Section 96 Modification Application SSD 6611
Renewal of Marine Structures Cockle Bay, Darling Harbour SSD
Determination (SSD 6611) Approved 13 Nov 2015

Applicant:	Place Management, Property NSW (Applicant formerly known as Sydney Harbour Foreshore Authority (SHFA))
Consent Authority:	Minister for Planning
Land:	Cockle Bay Darling Harbour (Lot 11 in DP 1082970, Lot 1010 in DP 1147364 and Lot 63 in DP 1009964)
Approval SSD6611:	Renewal of marine structures at Cockle Bay, Darling Harbour, Including: <ul style="list-style-type: none"> • Demolition and removal of the harbourside jetty, promenade and steps, convention wharf and marina, • Construction of a floating pontoon pedestrian walkway incorporating a 45 m pick up and drop off facility for passengers of charter and tourism vessels, private water transport services and water taxis; and • Construction of a floating pontoon marina providing 40 short stay berths, a water taxi pick up and drop off zone, and an event staging and event barge storage area.
S96 Modification:	To re-include 24.0 m length floating walkway adjacent to the Australian National Maritime Museum (ANMM) in two sections (11.25 m + 12.65m) @ 3.0 m wide, supported by fi

Figure 4: S96 Modification to re-include ANMM Walkway (3m wide)

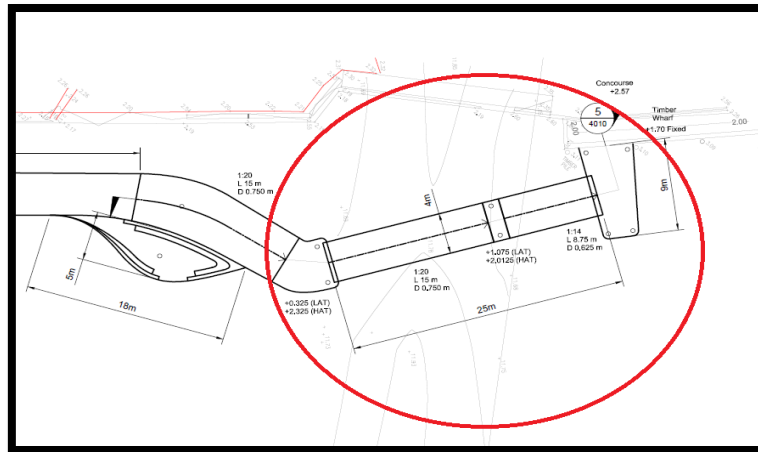
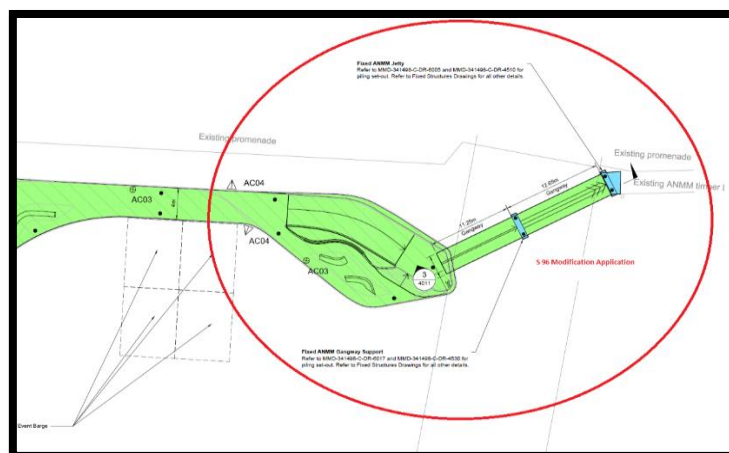
Figure 2: Original Proposal includes ANMM walkway (4m wide)

Figure 3: Deleted ANMM Walkway in response to RTS

- To re-include a section of proposed walkway (previously included in original application and notified in accordance with the regulations), adjoining the Australian National Maritime Museum (ANMM) which was deleted from the application in response to the “Reply to Submissions” (RTS) as no land owners consent (LOC) had been obtained from the ANMM.
- This proposed walkway was part of the original application and was included on the plans (previously advertised by the Department and considered in the consultant reports.)
- Approval is sought under Section 96 of the EP&A Act for the proposed walkway to be re-included as the ANMM requires the inclusion/continuation of the walkway adjoining the museum for added exposure to the general public in Darling Harbour (a State Significant Site) and so that there is pedestrian flow and not a ‘dead-end’.

The proposed ANMM walkway is designed in two prefabricated sections (11.25m + 12.65m) at 3.0m wide, supported by fixed supports including four timber and steel piles (Pile Numbers 24, 25, 26 & 27) (Refer 2.2 Plans attached to the S96 application below). There installation will be in three phases:
